RECALL BULLETIN 09V-337

DATE: October 5, 2009
 MODEL YEAR: 2007 & 2008
 CHASSIS MODEL: UD3300 with Locally Installed DUAL STEERING
 BULLETIN NUMBER: 09V-337

VOLUNTARY SAFETY RECALL CAMPAIGN NUMBER 09V-337 STEERING STOP ADJUSTMENT

Figure B

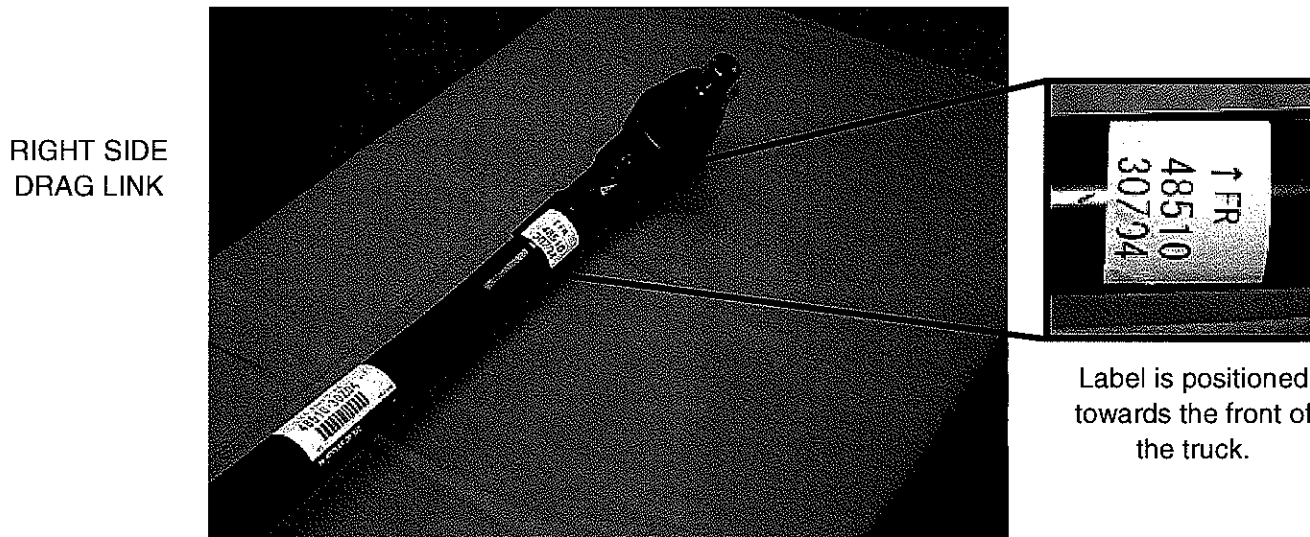
- A) The drag link should be installed with the directional arrow and part number label facing the front of the truck. The label may be covered with road dirt and the arrow not visible. The drag link is installed correctly if the label is positioned towards the front of the truck and steering gear. See figure B.

- B) If the drag link is installed correctly proceed to step 2.
- C) If the drag link is installed incorrectly remove the drag link and reinstall in the correct direction as shown in Figure B. Torque the nuts to 159 -253 lb.ft. and install the cotter keys.
- D) If the drag link has been damaged by contact with the tire, install a new drag link part number **4851030Z04**.
- E) Install the new drag link with the directional arrow facing the front of the truck. Torque the drag link nuts 159 -253 lb.ft. and install the cotter keys.

Figure C

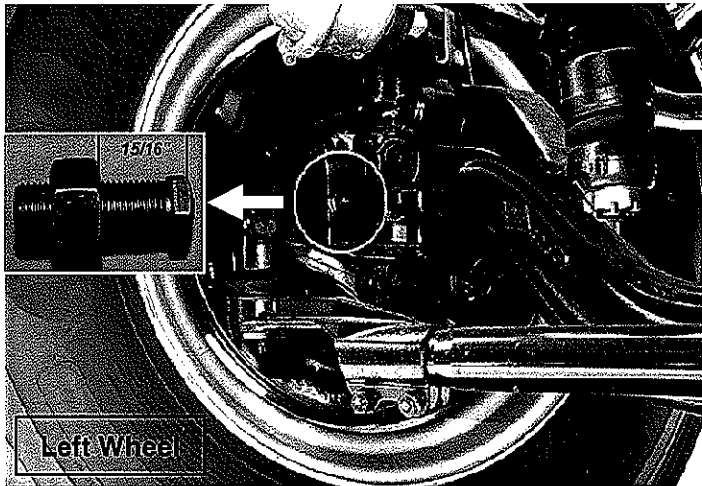
- 1) Adjust the steering stop bolt to protrude 15/16 inch from the top of the jamb nut to the top of the stop bolt hex. See Figure C insert.
- 2) Start the engine. The engine must be running and the tires on the ground to verify correct tire to drag link clearance.
- 3) Sitting in the **RIGHT** side drivers seat turn the steering wheel all the way to the **LEFT** and verify that there is a minimum of 1½ inch clearance from the inside of right front tire to the drag link as shown in Figure D.
IMPORTANT: You must use the **RIGHT** side steering position to verify the minimum clearance of 1½ inch.
- 4) If the clearance is not 1½ inch adjust the stop bolt out further until the required 1½ inch clearance is achieved.
- 5) Torque the steering stop jamb nut to 101-123 lb.ft.

Figure E

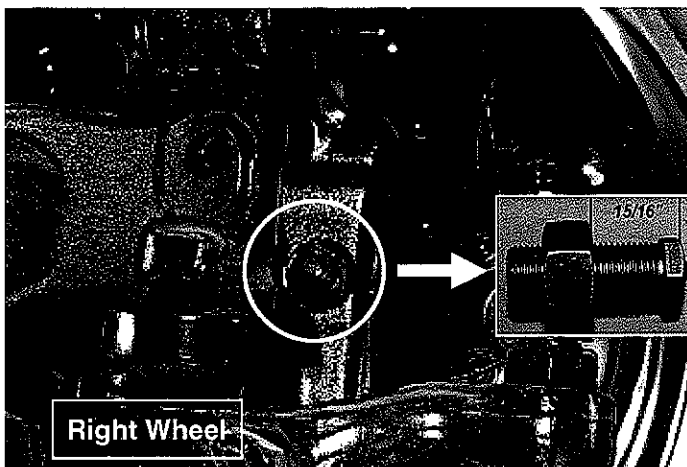
- 1) Adjust the steering stop bolt to protrude $15/16$ inch from the top of the jamb nut to the top of the stop bolt hex. See Figure E insert.
- 2) Start the engine. The engine must be running and the tires on the ground to verify correct tire to drag link clearance.
- 3) Sitting in the **LEFT** side drivers seat turn the steering wheel all the way to the **RIGHT** and verify that there is a minimum of $1\frac{1}{2}$ inch clearance from the inside of the **LEFT** front tire to the drag link. See Figure F.
IMPORTANT: You must use the **LEFT** side steering position to verify the minimum clearance of $1\frac{1}{2}$ inch.
- 4) If the clearance is not $1\frac{1}{2}$ inch adjust the stop bolt out further until the required $1\frac{1}{2}$ inch clearance is achieved.
- 5) Torque the steering stop jamb nut to 101-123 lb.ft.
